Delegated officer report for planning application

Application no.	141808/LO/2024
Date registered valid:	23 December 2024
Proposal:	Listed Building Consent for the installation of floor mounted air sourced heat pumps and living green wall enclosure to replace gas fed boilers, upgrade heating system, installation of roof mounted solar PV array, installation of fixed ladder access to rear elevations of the building and roof mounted mansafe system.
Address:	Blackley Cemetery And Crematorium, Victoria Avenue, Manchester, M9 0NG
Ward(s):	Higher Blackley Ward
Applicant:	Martyn Joyce, Manchester City Council
Agent (if any):	Drees & Sommer UK Ltd
Case officer:	Ellie Knowles Tel: 0161 219 6633 Email: ellie.knowles@manchester.gov.uk
Recommendation:	Approve
Date of recommendation:	2 June 2025

Figure.1. Roof plan of proposed solar PV arrays to Crematorium

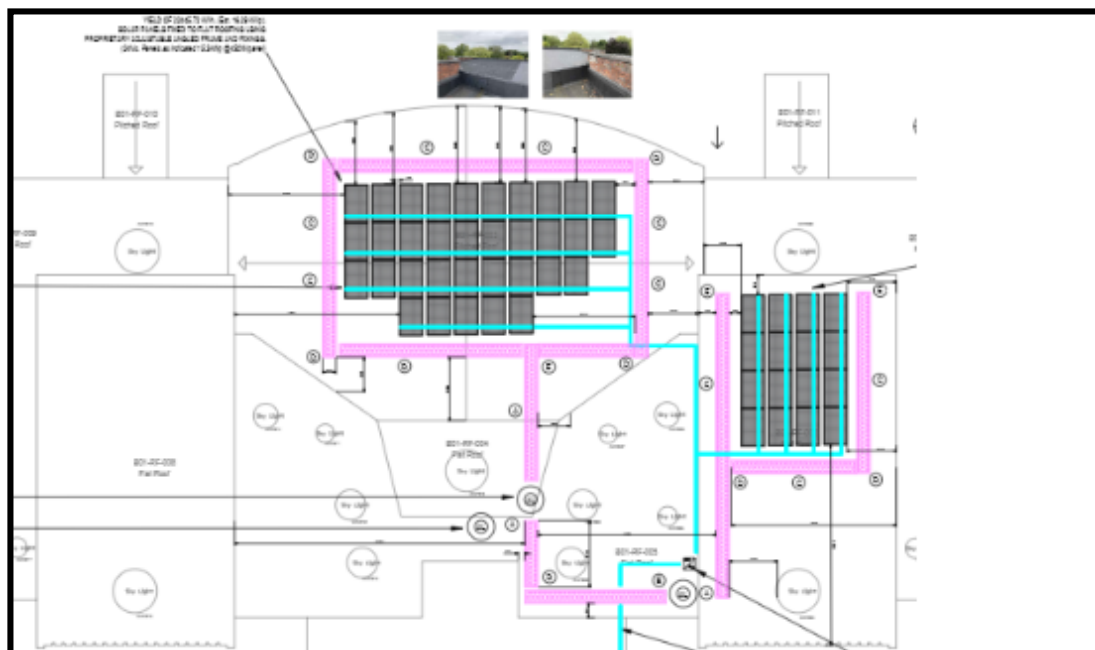
Fifty solar PVs will be sited on the chapel roof split into two groups; 34no will be sited in 4 rows on the flat roof over the main chapel, and 16no. will be sited in 4 rows on the flat roof of the side chapel to the south-east (see Fig.2). All panels are 450W and no additional strengthening works are required to support the installation.

During the site visit meeting (September 2024), it was emphasised that the solar PVs should not be visible on approach to the chapel, especially from the front elevation of highest significance and that the angle of tilt should be set to the lowest point to protect the special interest of the building. This follows the guidance from Historic England Advice Note 18, para. 96 which states that, *"Care is required, especially in considering the aesthetic impact of panels on significant views of the building"*.

In relation to the main chapel, they would also be set back off the shallow bowed parapet with gaps to the edge ranging between 2.5 metres and 3.4 metres with a maximum upstand of 336mm, by which 205mm would exceed the height of the existing parapet. Those on the east chapel would be sited on the higher section of roof set back 5.2 metres off the front elevation and 15 metres off the side elevation.

The gaps together with the maximum height off the plane of the roof and low angle, are likely sufficient to avoid any views of the PVs.

The Heritage Assessment has considered that any views of the PVs from the front elevation would diminish on approaching the building and that if they were visible to some extent, would interrupt the clarity of the design and simplicity of the roof. This would amount to less than substantial harm to the heritage asset at the lower end of the harm scale, triggering the public

In response, the submitted drawing 3384-CWC-XX-EX-DR-E-6100 Rev T3 shows mitigation wherein the PVs for both the main and east chapels are fitted onto a tilted mounting system at a 10° angle, the lowest where any meaningful solar gain can be achieved (the optimum angle for PVs in Manchester is 14° in summer and 60° in winter).

Figure.4. Proposed ASHP living green wall enclosure

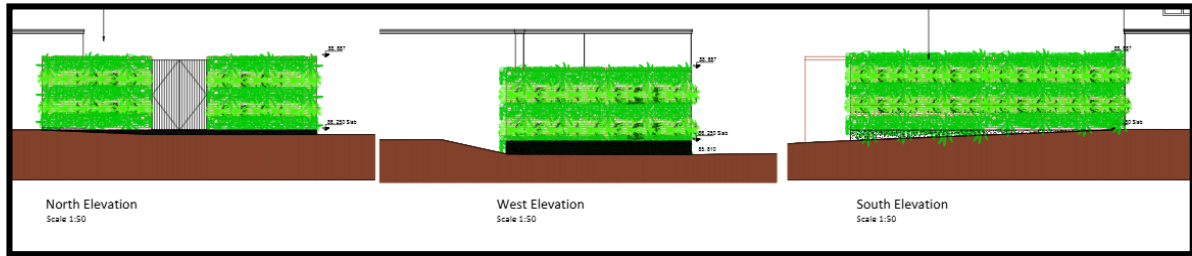
As shown on drawing 3384-CWC-XX-EX-DR-E-6100 Rev T3, this element comprises of a 2.9-metre-high brick compound colour-matched to the plant room wall with double timber gates for maintenance access and will be surrounded by the Biotecture living wall (see Fig.4).

The Biotope living wall system is a high-quality product which will assimilate well with the existing planting at the back of the chapel further reducing the visual impact of the enclosure. An automatic irrigation system fed through the crematorium water supply will ensure that the planting is well maintained.

Less than substantial harm would be derived from disrupting the symmetry of the rear elevation when seen from the public Memorial Garden. On balance this is acceptable given the wide public benefits of the proposal which make a clear and convincing case in support. The main benefit is enabling the crematorium to reduce its operational carbon cost, delivering an historically carbon intensive public service in the most sustainable way without future reliance on the existing high gas consuming system. The proposal is supported by Core Strategy policies EN4, EN6 and EN8 and at the GM level where the Council has signed up to the Climate Change Action Plan with a view to becoming net zero carbon by 2038.

Figure.5. Proposed Access Ladder Locations on Crematorium roof

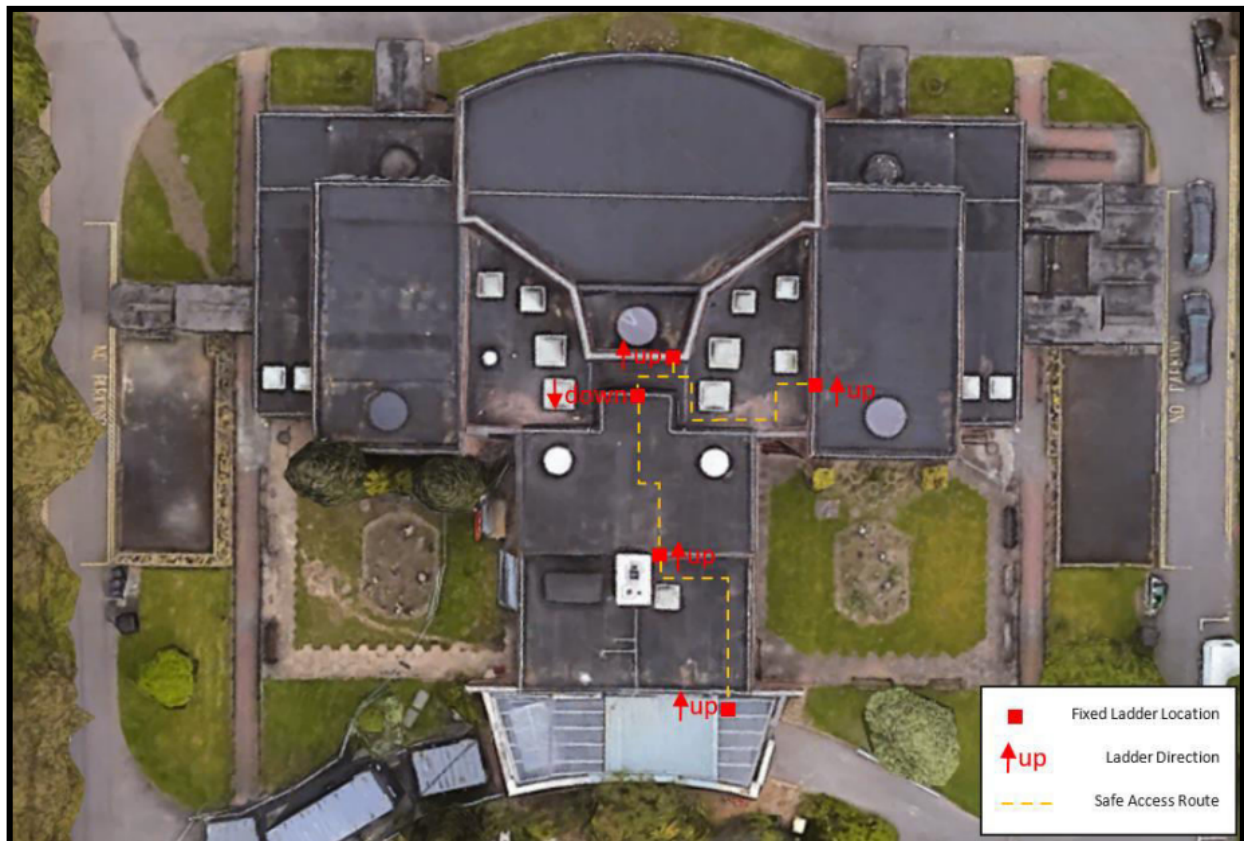
5no. roof-mounted vertical fixed ladders with an over-rail system are proposed for maintenance of the solar PVs, chapel roofs and associated works and are necessary for the operative to safely harness onto.

Two will give access to the main chapel roof, one to the eastern side chapel, one to the chimney and one is sited over the rear plant room. They are retractable, folding from 500mm wide in the open position to 185mm when closed and are necessary as the roofs have several level changes with an inclined roof over the main chapel.

Because of the differing heights of the roof, the ladders will mainly be concealed from public views on the ground. Drawings 24598.004 and 24598.005 show no visibility from the most significant views at the front of the chapel. There would however some visibility of the over-rail system from the eastern and western elevations where over-rail rises 1 metre over various parapets.

Their impact on the character and appearance of the heritage asset is negligible being sited in areas of the building that contribute least to its significance.
